J:\Planning\Traffic Studies\Locations\Community-wide\Harrison West Society\2014-09-17 Meeting Recommendations\Handout Side 2-Updated 01-4-12-15.pptx

## Changes to be Implemented

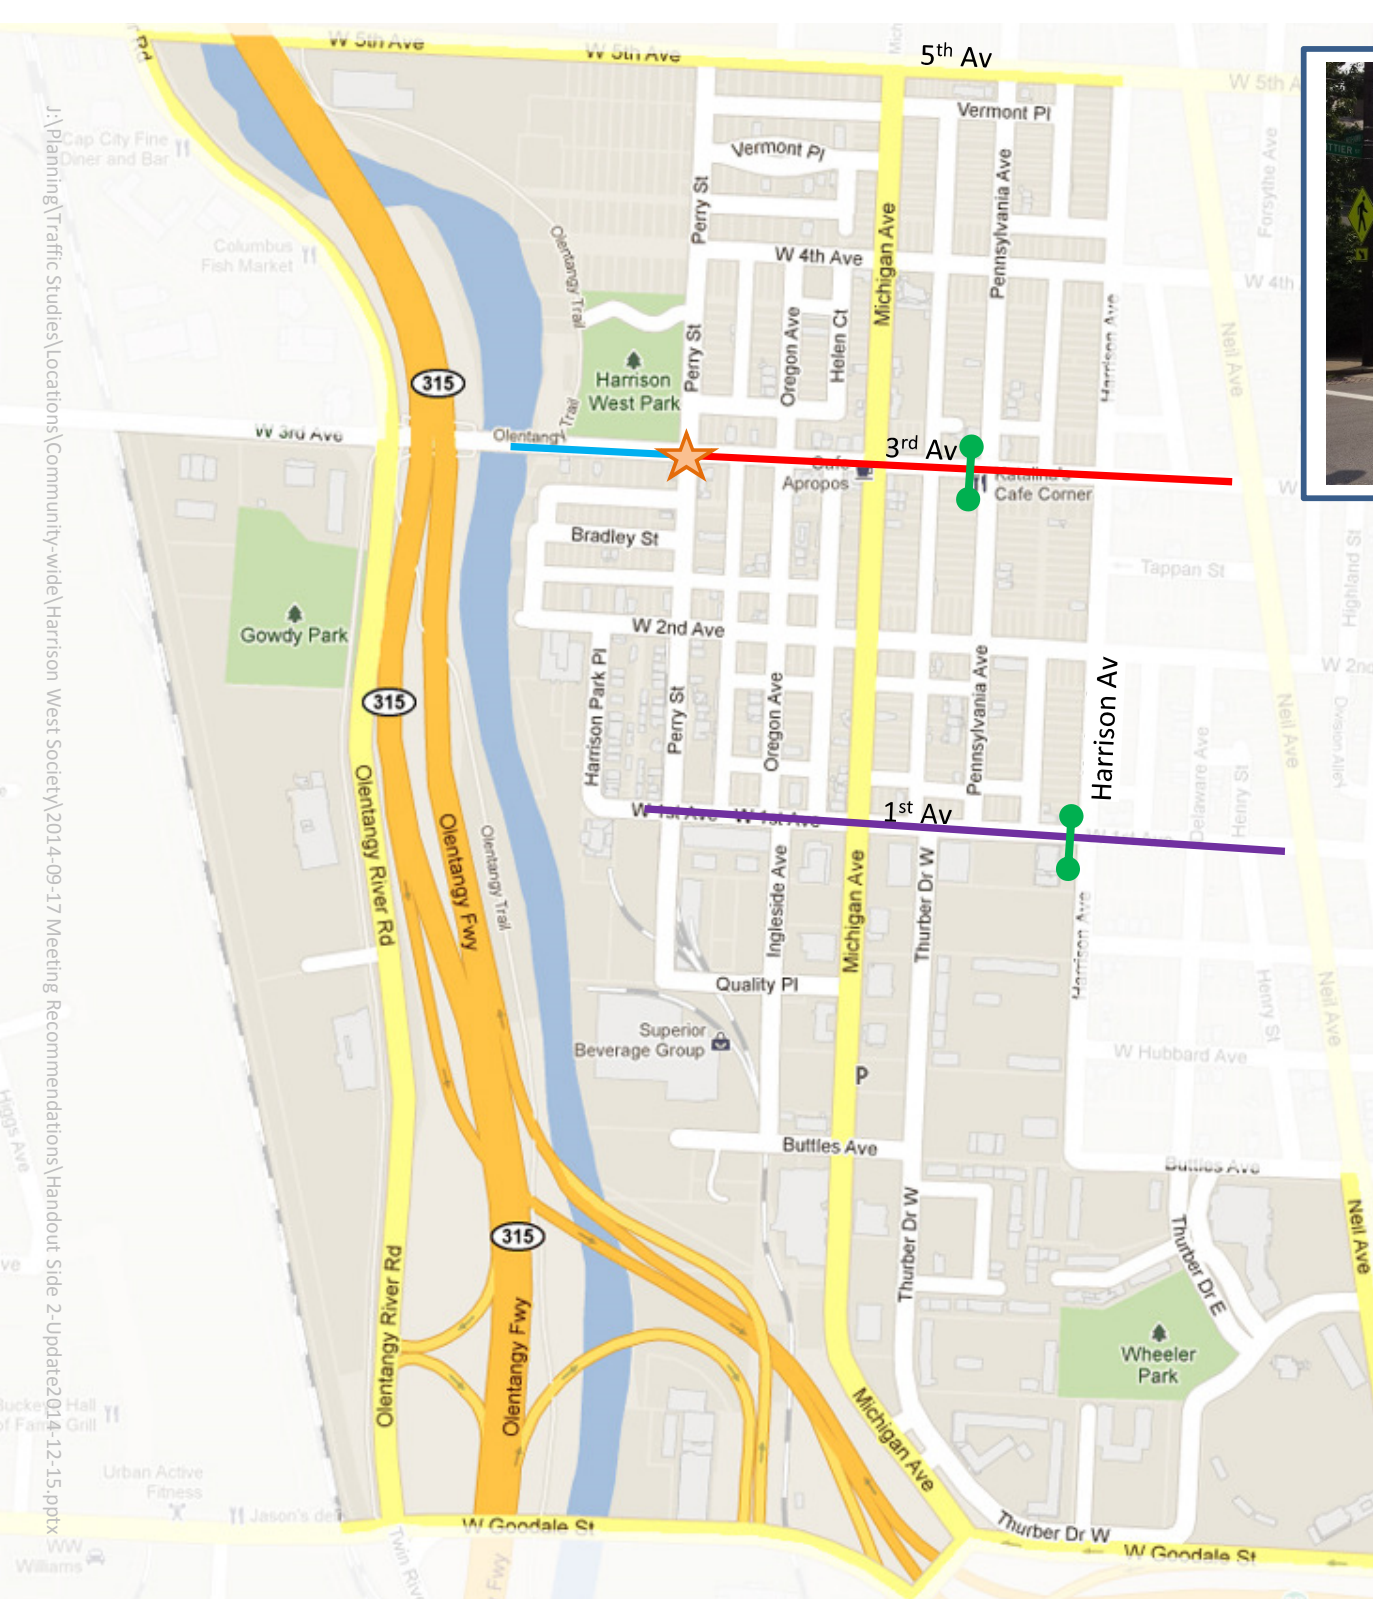
- Remove approximately 4 parking spaces on the south of 3<sup>rd</sup> Av, West of Perry St. Parking stalls to be marked.
- Install Type 1 crosswalk, west leg of intersection
- ★ 1) Install “cross traffic does not stop” signage in addition to the stop signs present on Perry St at 3<sup>rd</sup> Av  
2) Install Type 1 crosswalk on east and west approach of the intersection, including pedestrian crossing paddles in the roadway centerline.
- Stripe parking lane, similar to Neil Av. Consideration for bus stops will be required\*.
- Stripe parking lane due to traffic calming concerns found to be present\*.

*\*\*Voted and approved by Harrison West Society 10/15/14, to be completed Spring 2015 due to weather and temperature requirements of the pavement marking material. All other improvements were implemented Fall 2014.*
